Department of Planning & Community & Economic Development

November 22, 2016

RE: Approval of a conditional use to reuse a portion of a former place of worship and school for business and professional offices at **2670 Milwaukee Street**.

OPERATION FRESH
 START
 SITE PLAN
 1"=30' (11X17)
 Parking:
 COMM. TENANT - 25
 OFS PARKING - 42
 TOTAL STALLS - 67

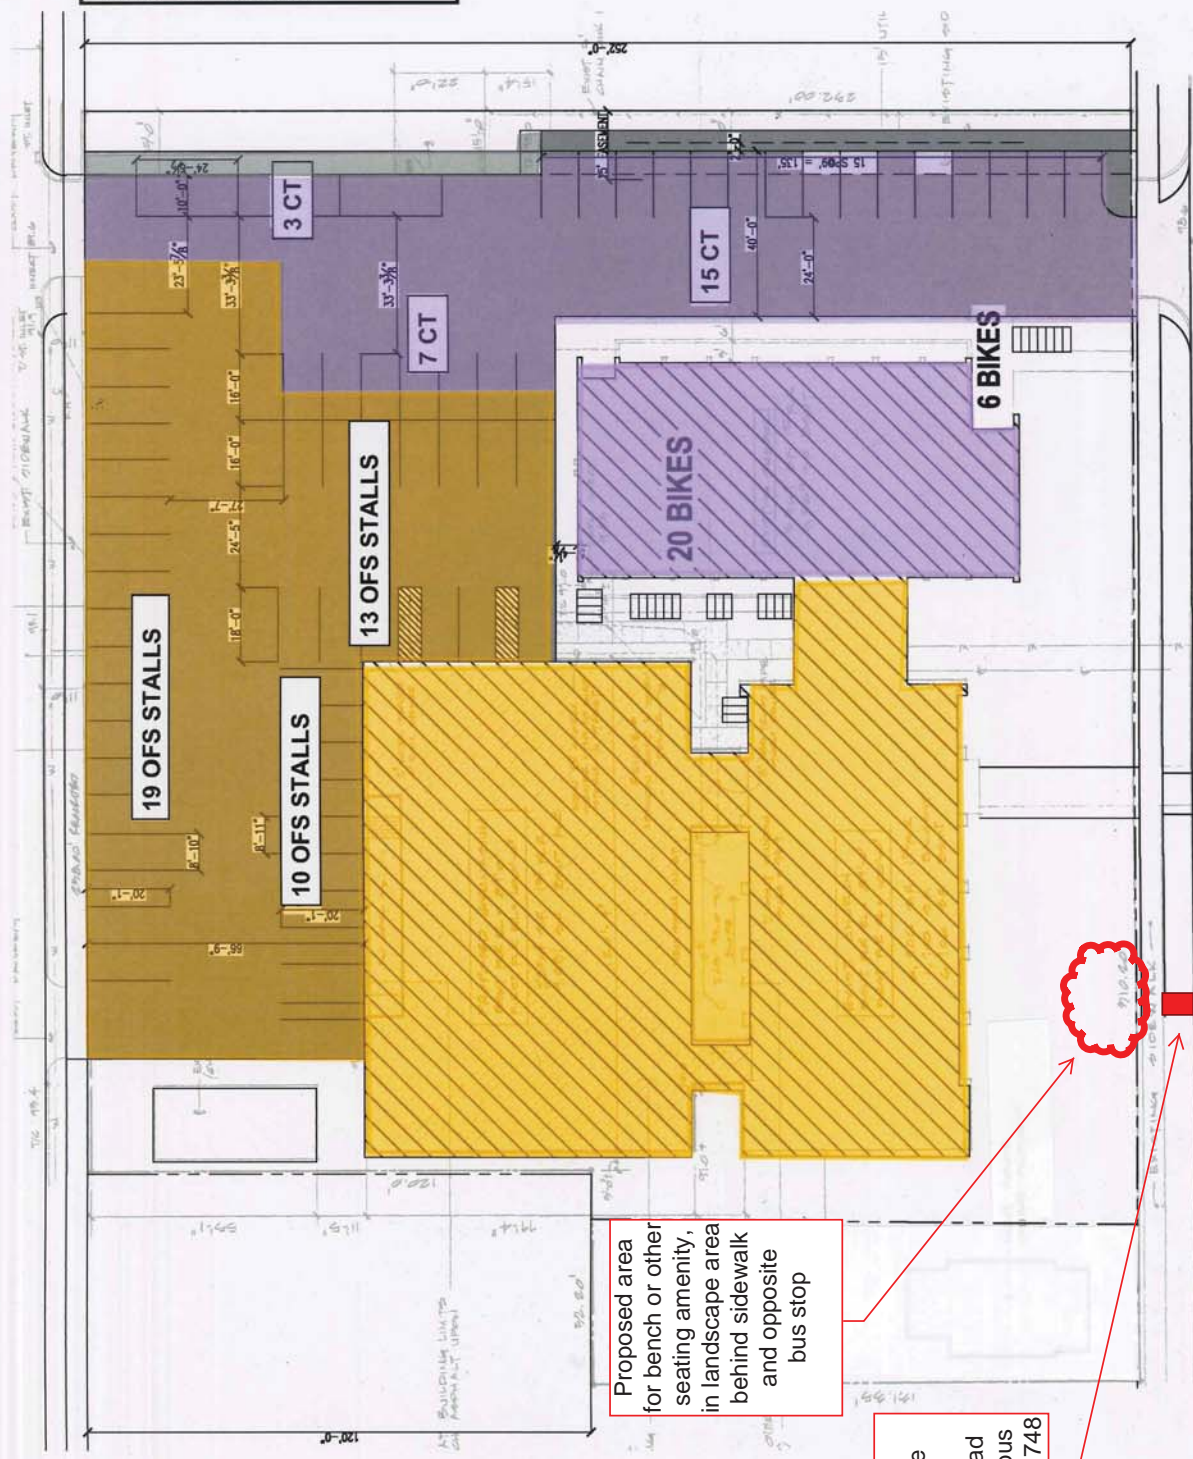
26. In coordination with public works improvements, the applicant shall maintain or replace the concrete passenger boarding pad at the existing Metro bus stop on the north side of Milwaukee Street, east of Farwell Street (#1748).

27. The applicant shall install and maintain a bench or other seating amenity in the adjacent property landscape plan, behind the sidewalk and opposite this concrete passenger boarding pad area.

28. The applicant shall include the location of these transit amenities on the final documents filed with their permit application so that Metro Transit may review and approve the design. [See attached document '2670ms_METRO.pdf']

29. Metro Transit operates daily transit service along Milwaukee Street through the Farwell Street intersection, adjacent the project site. Bus stop ID #1748 is adjacent the proposed project site, with the signed bus stop zone encompassing the area from intersection east approximately 100 feet.

Proposed area for bench or other seating amenity, in landscape area behind sidewalk and opposite bus stop

Existing accessible concrete boarding pad and Metro bus stop zone #1748
